SUBJECT: UNIT 1 OFFSITE DOSE CALCULATION MANUAL Revision 9

Enclosed is Revision 9 to the Unit 1 Offsite Dose Calculation Manual (ODCM). This revision accomplishes several tasks, chief among them is the modification of the ODCM to reflect the permanent shutdown of Unit 1. With the permanent shutdown, these following systems are removed from service and were deleted from the ODCM: steam generator blowdown, containment purge, waste gas storage system and various instrumentation associated with the plant vent stack monitoring system. Also incorporated into this revision are the updates of tables used in the gaseous dose calculations that resulted specifically from the 1992 Land Use Census. Further, major changes were made as a result of an evaluation of the Radiological Environmental Monitoring Program. None of the above changes have any impact on the accuracy or reliability of methods for determining dose or setpoint values.

S01-ODCM
Revision 9
08-04-93

SONGS 1 Liquid Waste-Discharge System
Figure 4-1

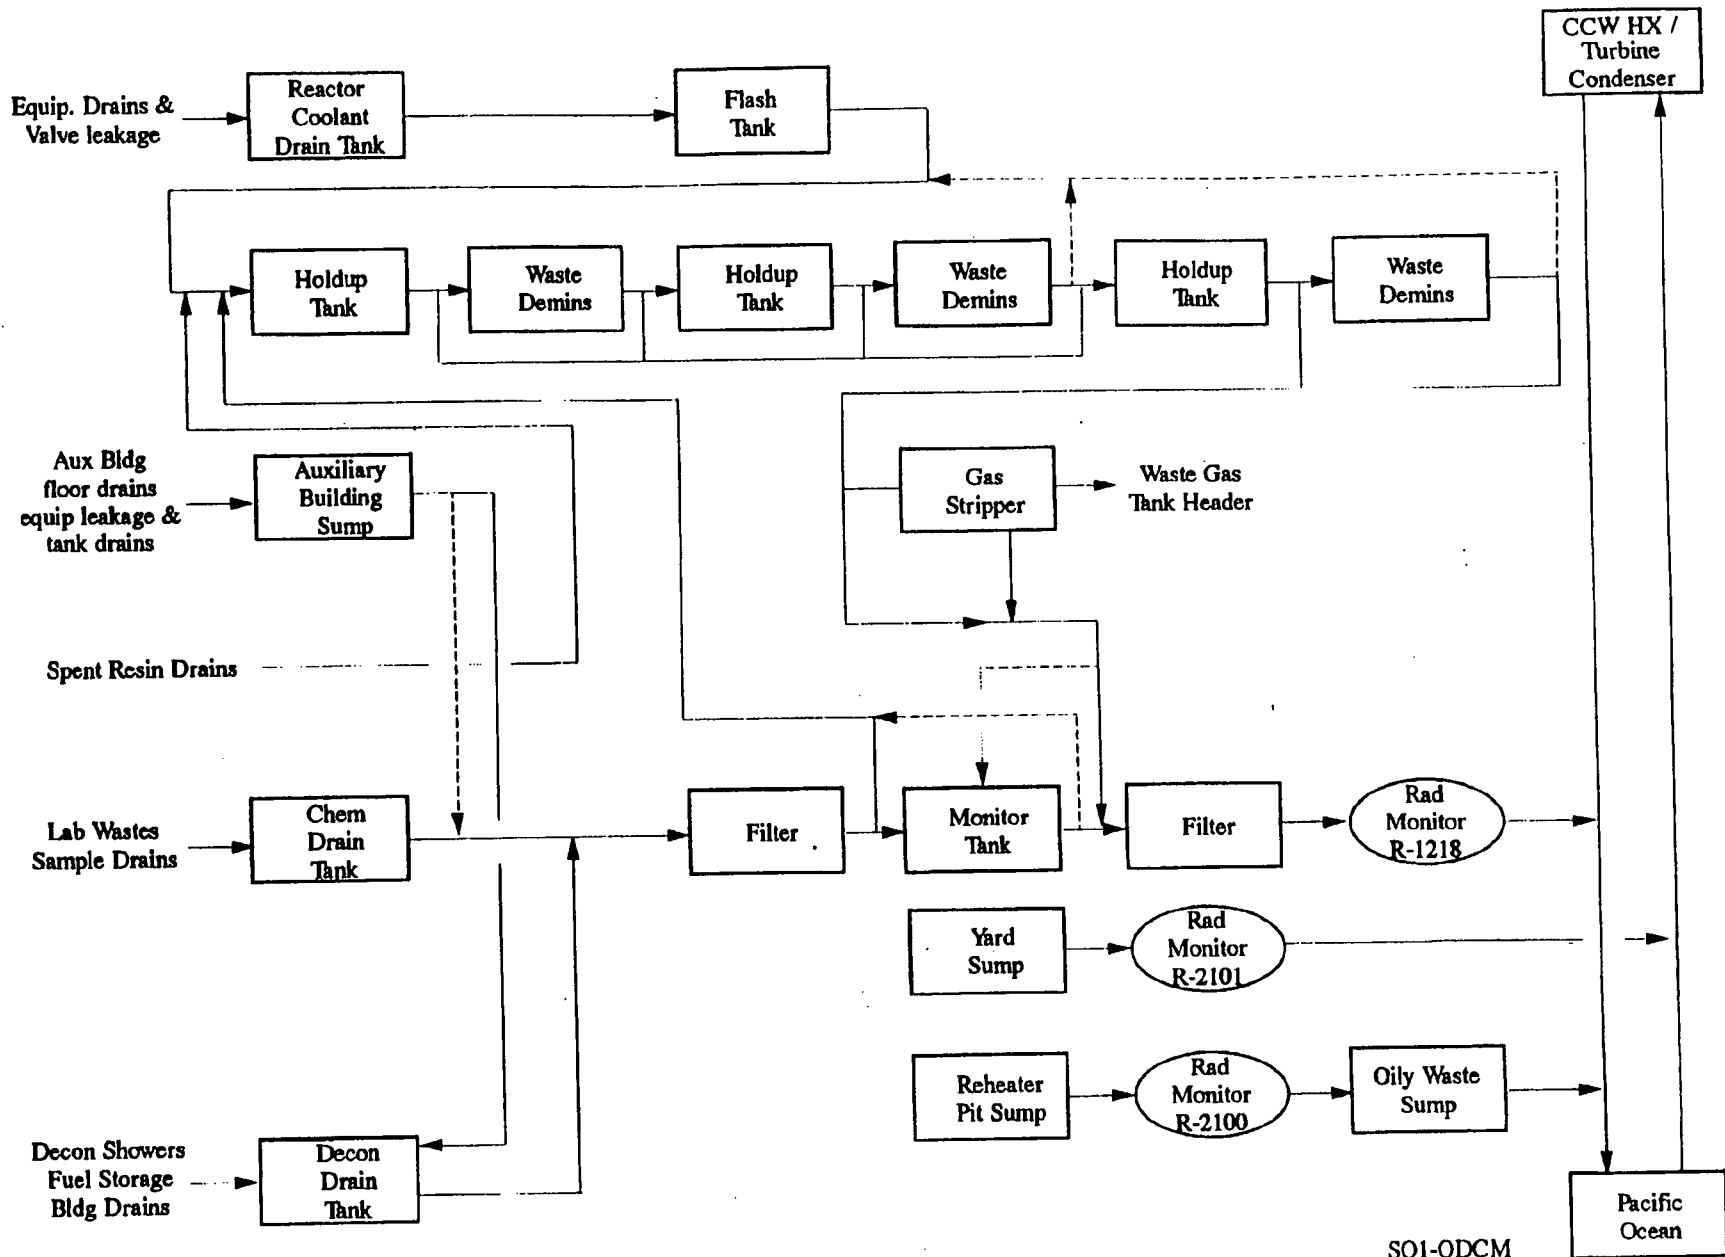
- 4-9[#] Deleted action 21 (gross activity monitors deleted on p. 4-8).
- 4-11[#] Deleted RT-1214, RT-1212, and RT-1211 sampler.
- 4-13[#] Modified Figure 4-1.

SONGS 1 Radioactive Gaseous Waste System
 Figure 4-2

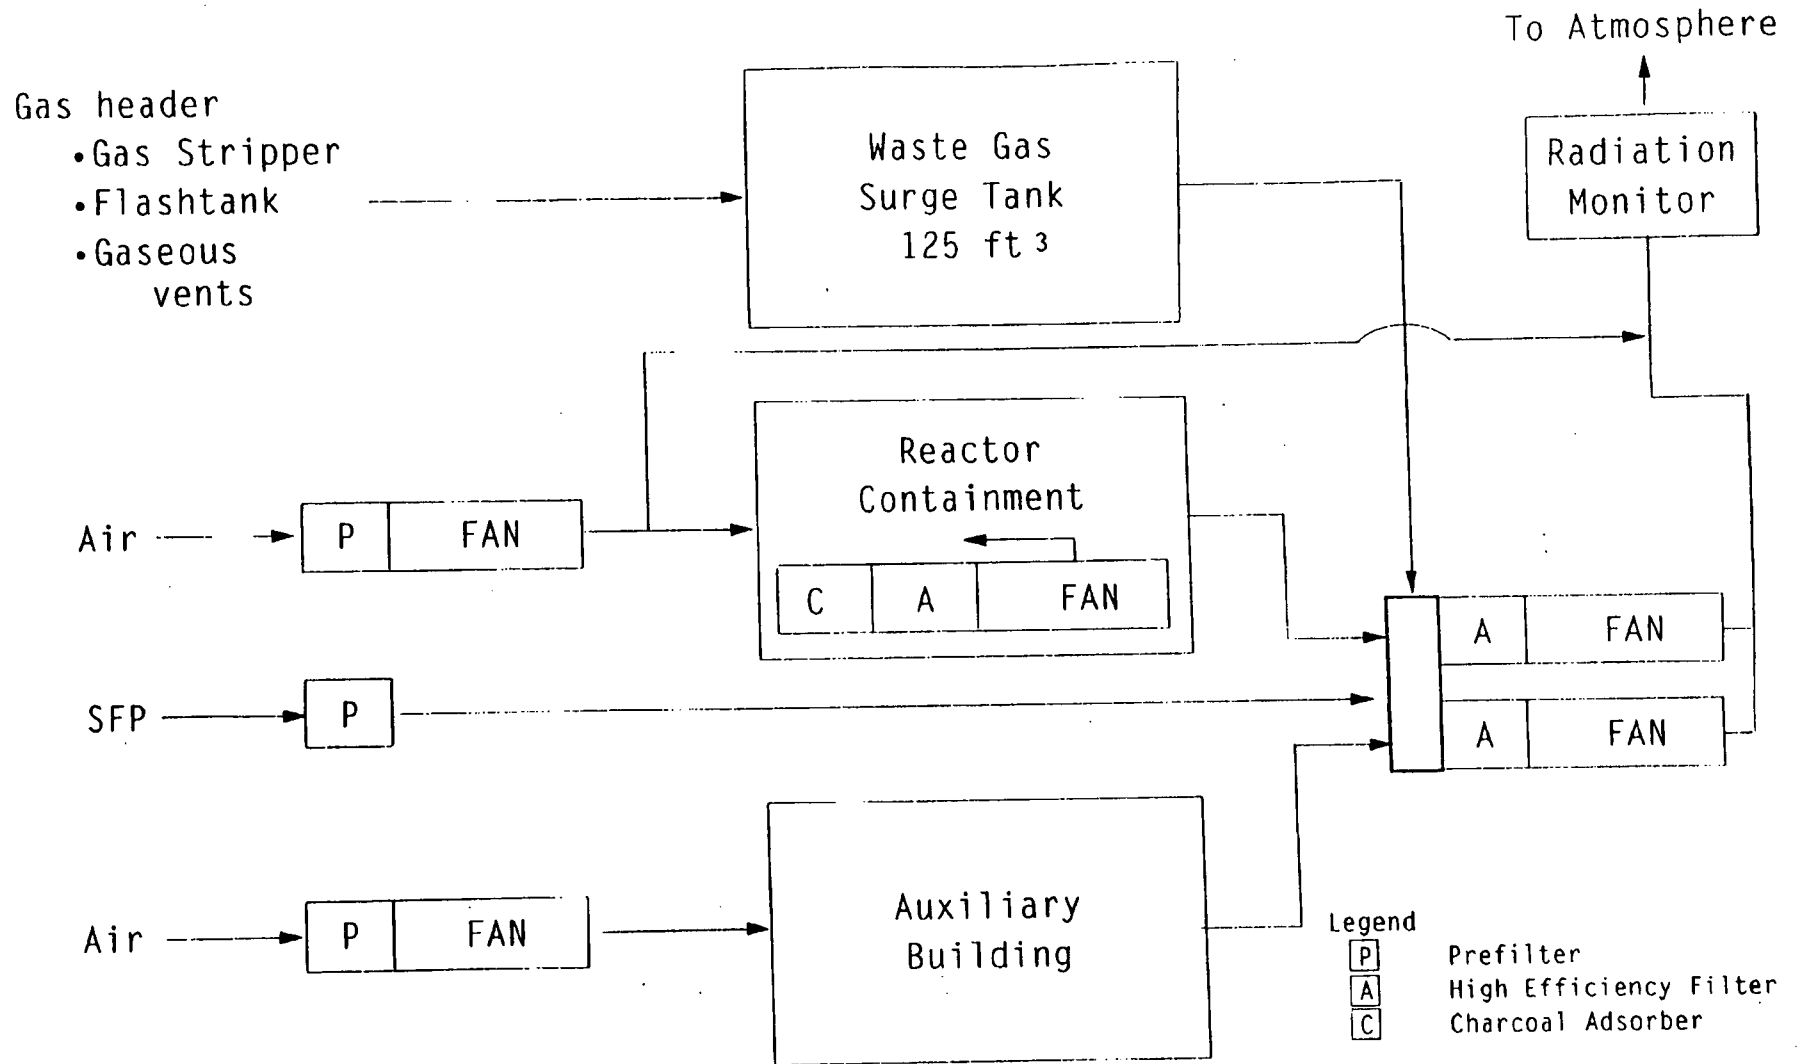
4-14[#] Modified Figure 4-2.

SONGS 1 Solid Waste Handling
 Figure 4-3

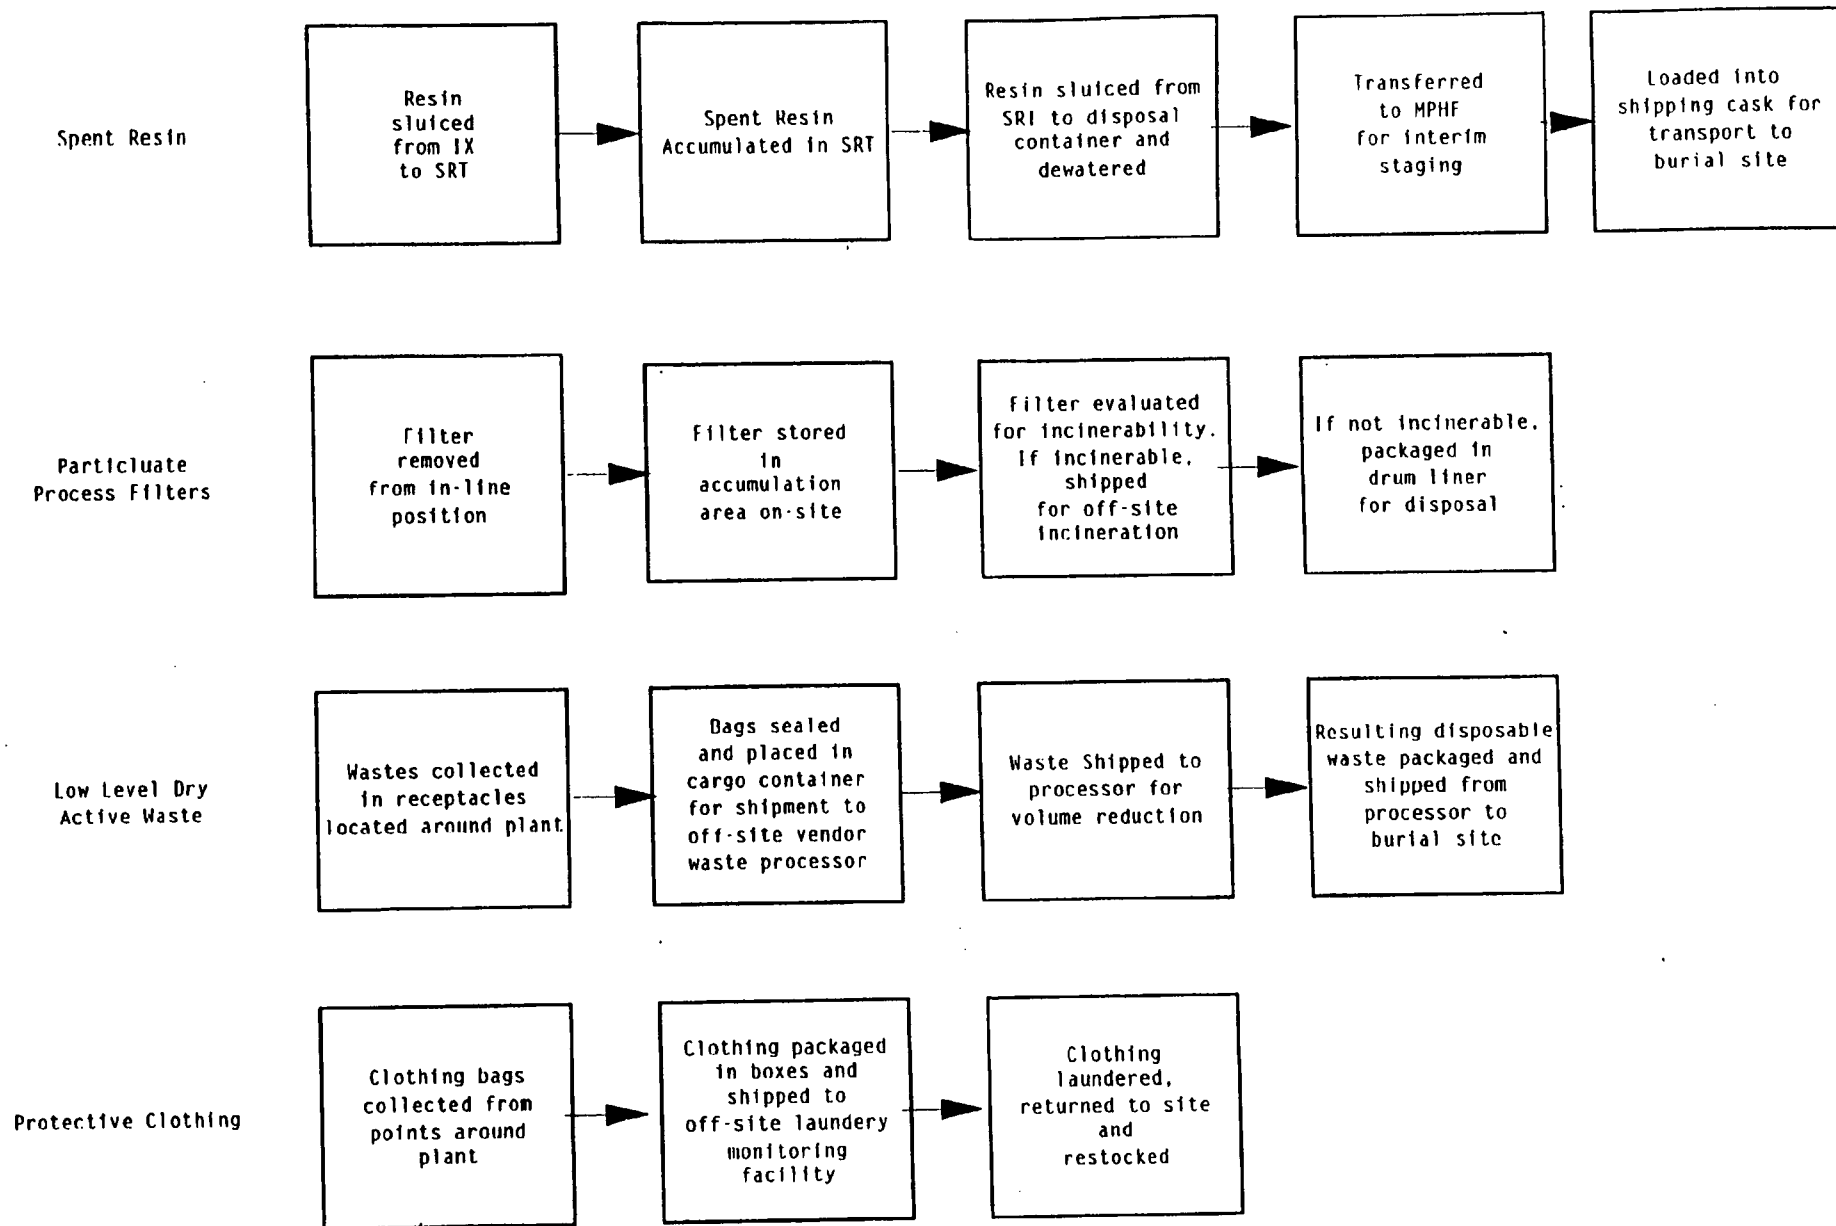
4-15 Modified Figure 4-3 to reflect current solid radwaste procedures.

Figure 5-1
Radiological Environmental Monitoring Sample Locations

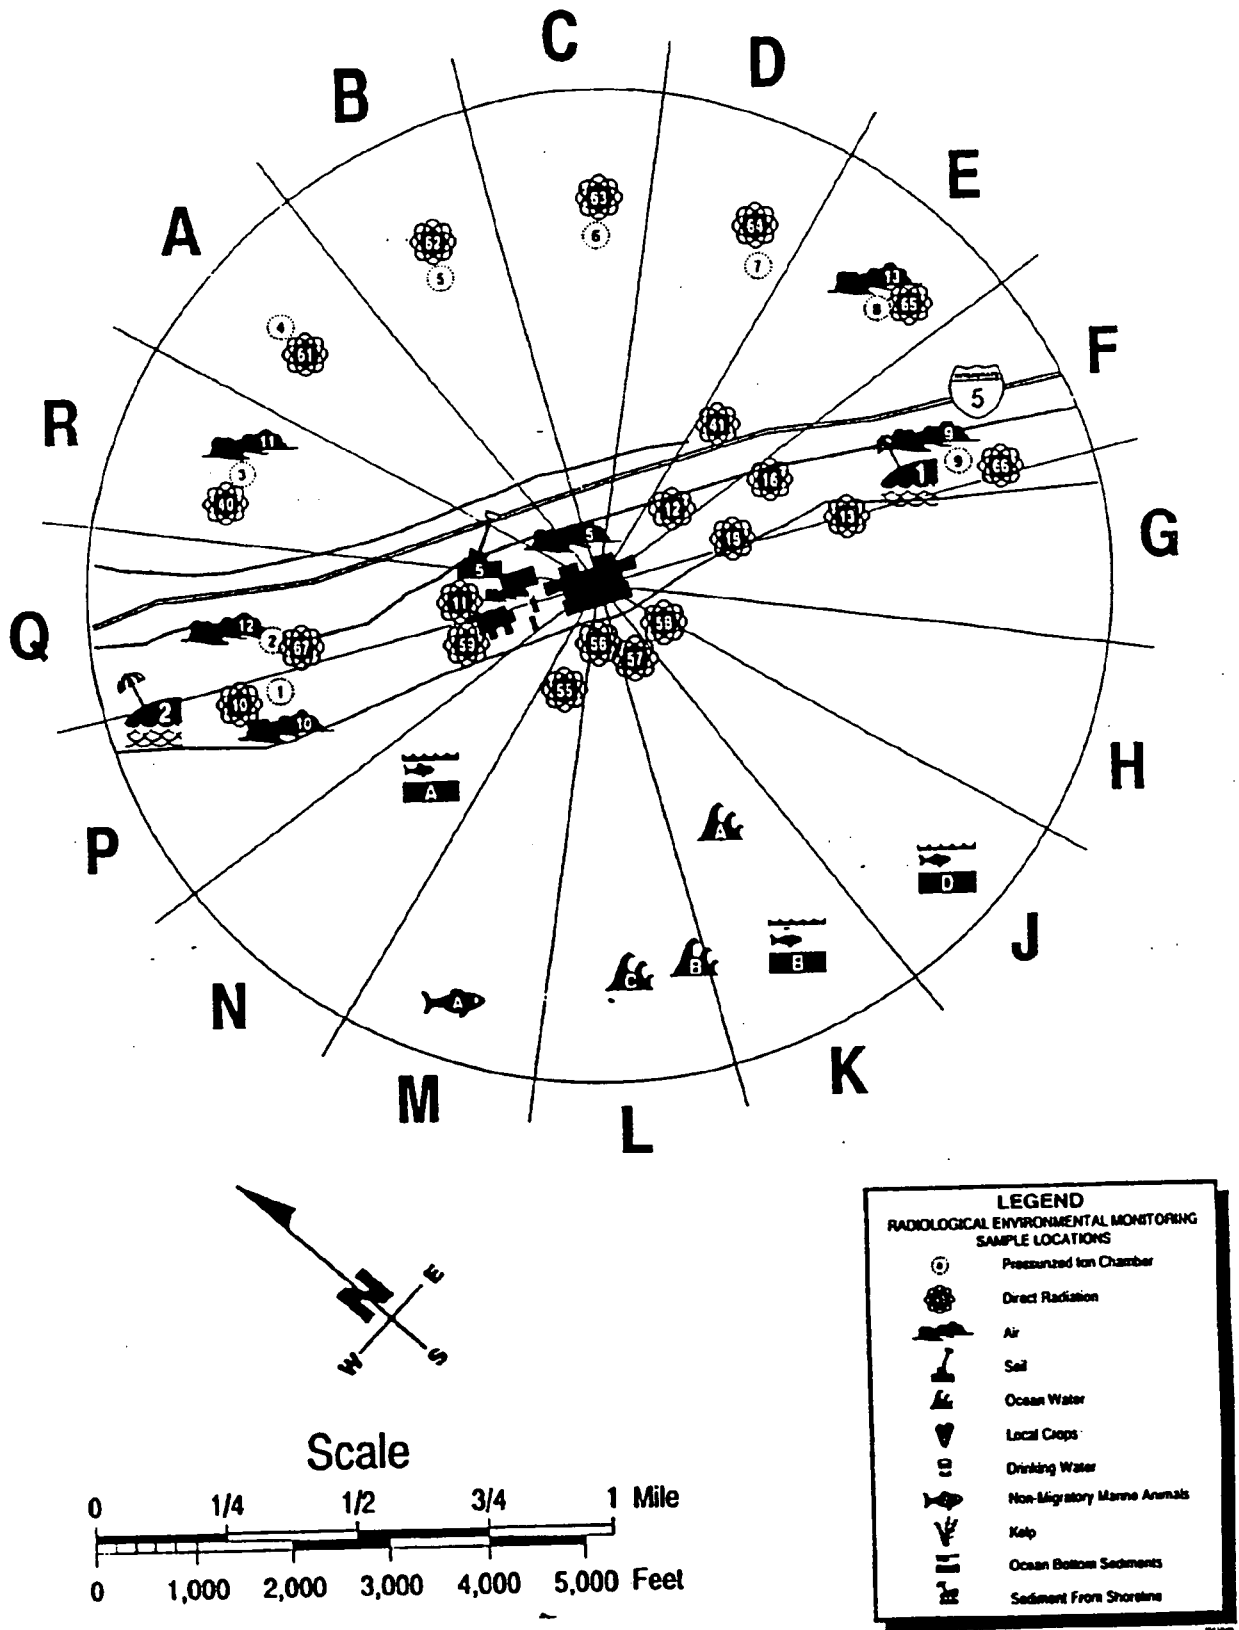
5-26* Revised Figure 5-1.

Figure 5-2
 Radiological Environmental Monitoring Sample Locations - San Diego County
 5-27

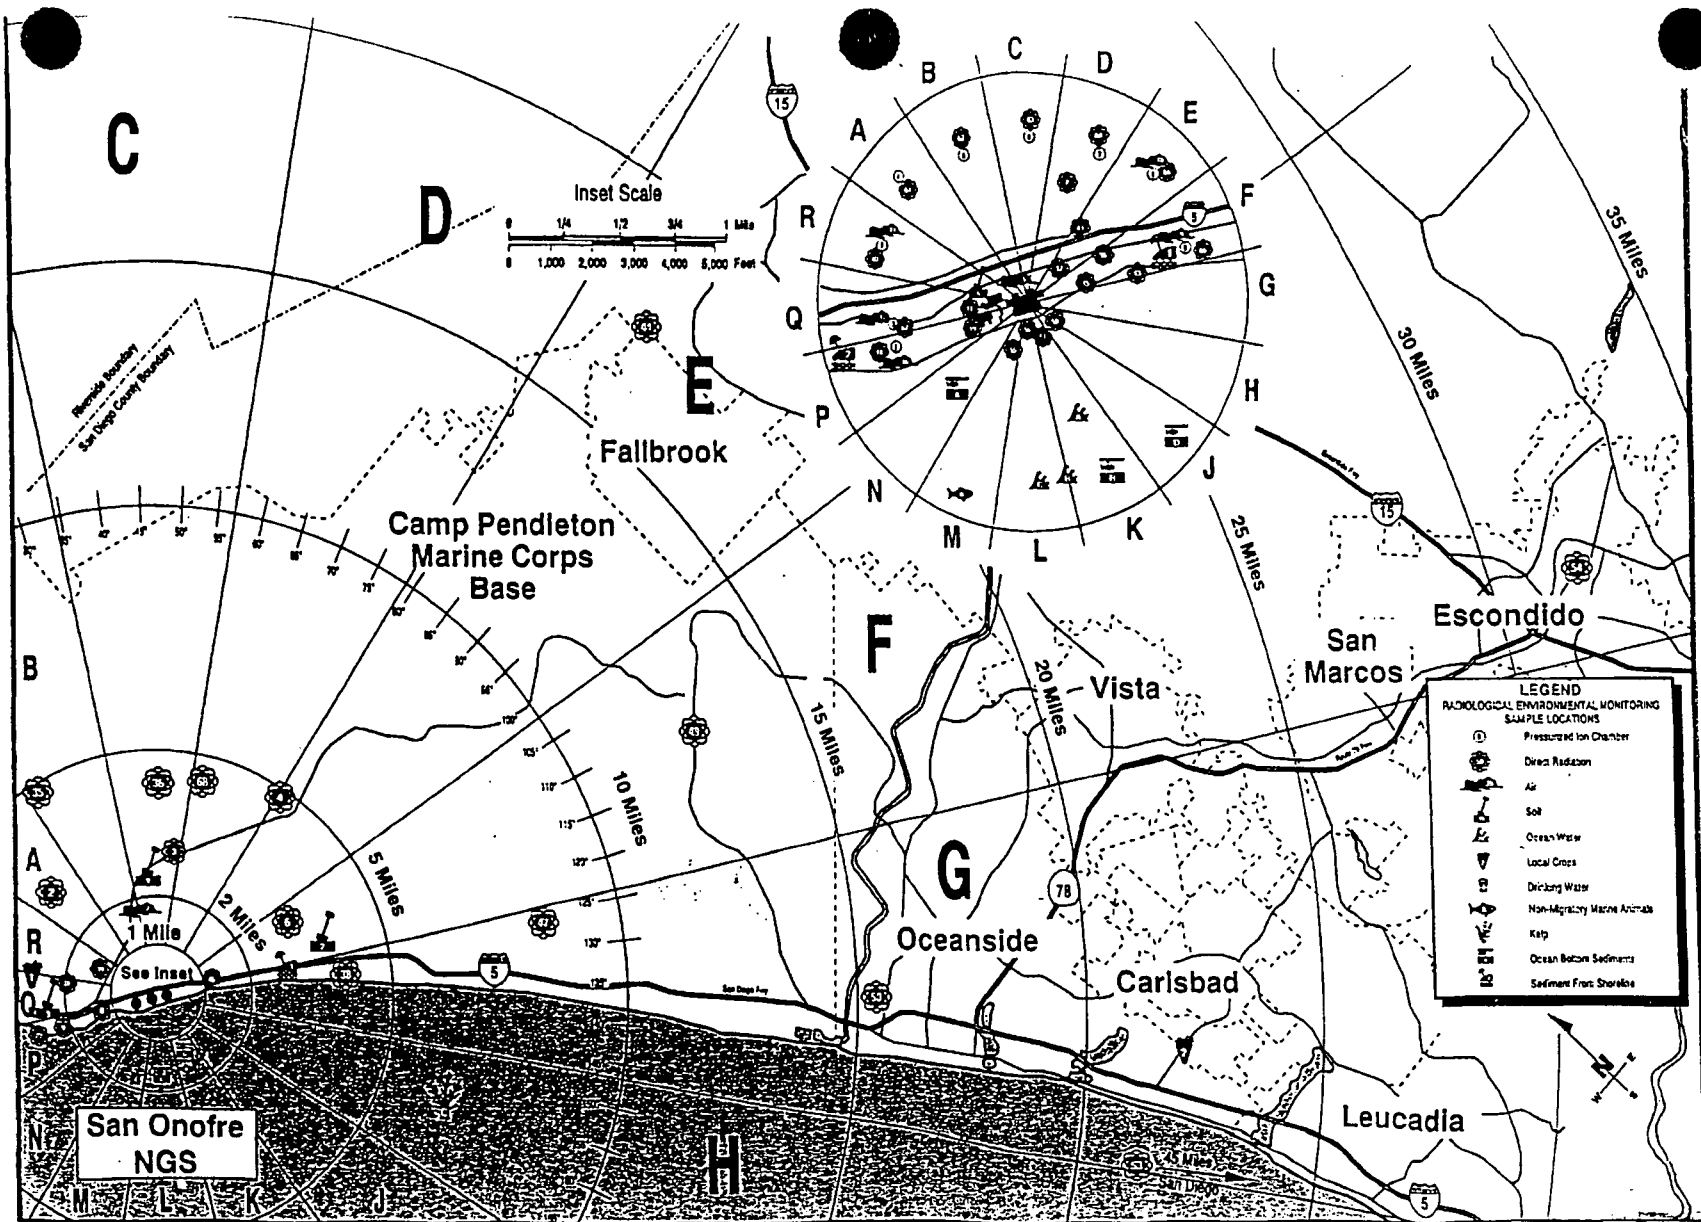
5-27* Revised Figure 5-2.
